N-853-1 Proposed Revision

Travis Olson, Framatome
NRC/EPRI Technical Exchange
Meeting
March 7, 2023

Proposed Changes

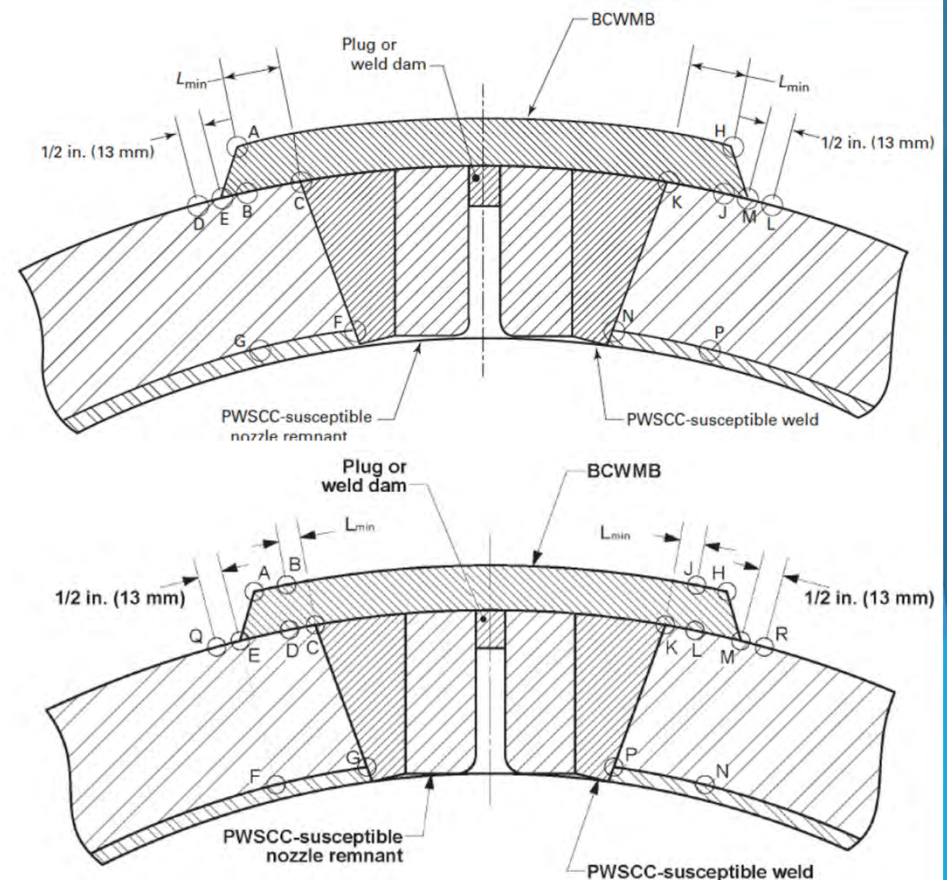
- ▶ All technical changes are associated with UT volumetric examination requirements
 - ▶ Section 3 - Fabrication Examination
 - ▶ Figure 6 - Surface and Volumetric Acceptance Examination for BCWMB Prior to Nozzle Welding
- ▶ Intent of revision is to allow use of ASME Section XI acceptance criteria and bring N-853 into alignment with other ASME C&S
 - ▶ Distinguish volumetric exam requirements for structural versus non-structural
 - ▶ Brings into alignment with other ASME C&S:
 - ▶ Non-Mandatory Appendix Q
 - ▶ N-740-3 (Draft)
 - ▶ N-894 (Draft)

N-853 and N-853-1 Figure 6

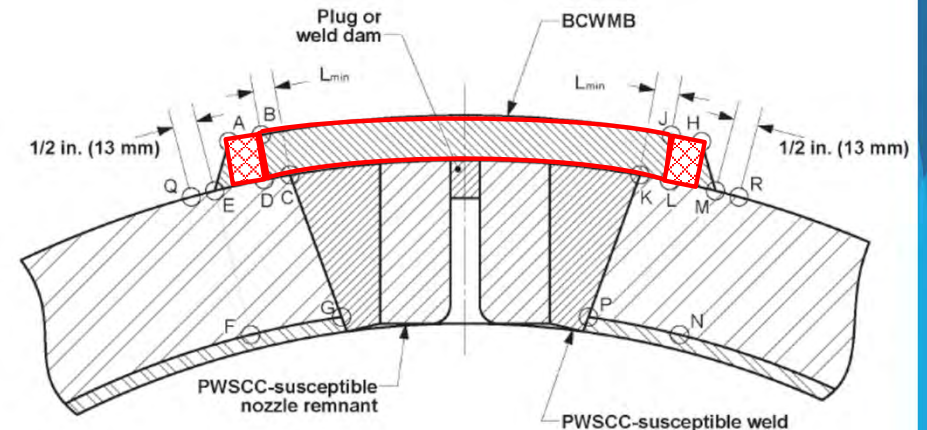
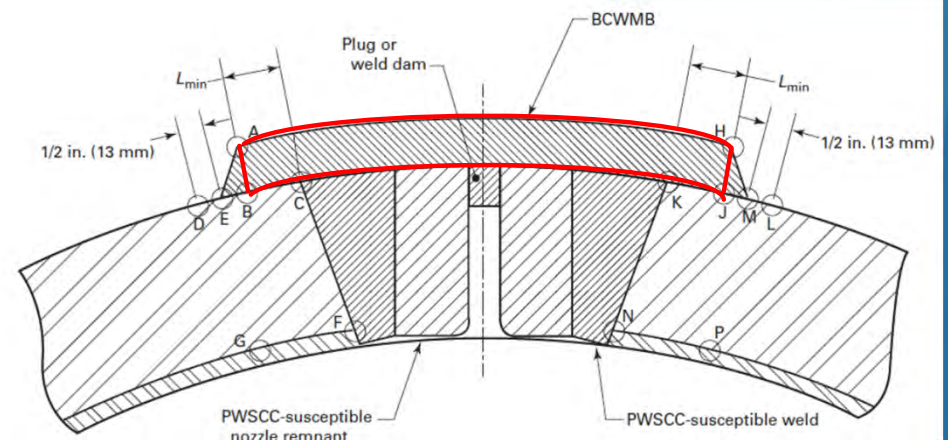
- ▶ Current revisions require qualification to Section V and acceptance criteria of NB-5330
- ▶ Proposed revision would permit qualification to Section XI Mandatory App. VIII, Supplement 11, using IWB-3514 pre-service acceptance criteria

- ▶ Current revisions require essentially 100% of the BCWMB to be volumetrically examined for planar flaws (volume A-H-J-K-C-B)
- ▶ Proposed revision would require structural portion of BCWMB (volume B-J-L-K-C-D) to be examined for planar flaws. Non-structural portion (volumes A-B-D-E and H-J-L-M) would only be examined for laminar flaws for reduction in UT coverage (not to exceed 10%) of the structural portion of the BCWMB only

Proposed N-853-2 Figure 6
